Dealer Service Instructions for:

# **Safety Recall R42 / NHTSA 15V-542 Transmission Control Module**

**2013 - 2015 (PF) Dodge Dart**

Figure 3 – Original TCM Mounting Bracket and Nut

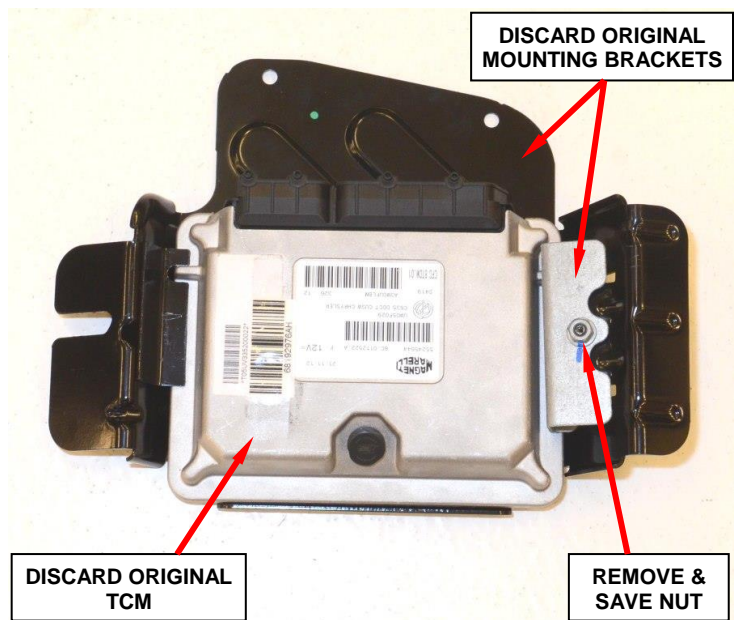
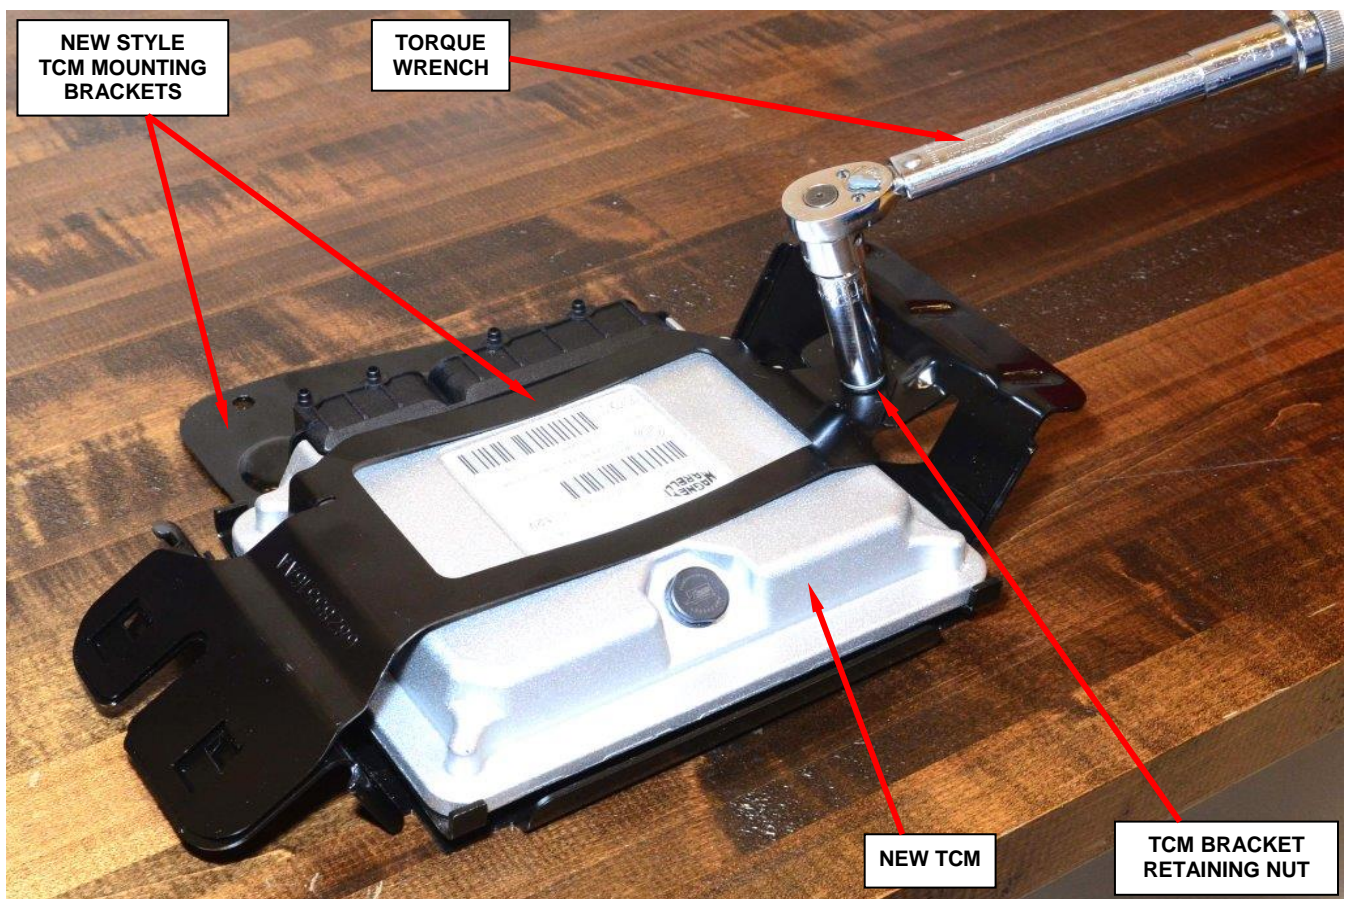
The Transmission Control Module (TCM) mounting bracket on about 23,500 of the above vehicles may cause the printed circuit board solder joints to separate, resulting in an electrical open circuit in the TCM. An open circuit in the TCM could cause the transaxle to shift into “Neutral” without warning. Having the transaxle unintentionally shift into “Neutral” under certain driving conditions could cause a crash without warning.

The Transmission Control Module and the Transmission Control Module mounting bracket must be replaced on all involved vehicles.

12. Remove and save the nut securing the TCM to the mounting bracket (Figure 3).
13. Discard the original TCM and mounting bracket (Figure 3).
14. Place the new TCM in position on the new mounting bracket.
15. Install the new TCM retaining bracket and retaining nut to the mounting bracket stud. Tighten the nut to 62 in. lbs. (7 N·m) (Figure 4).
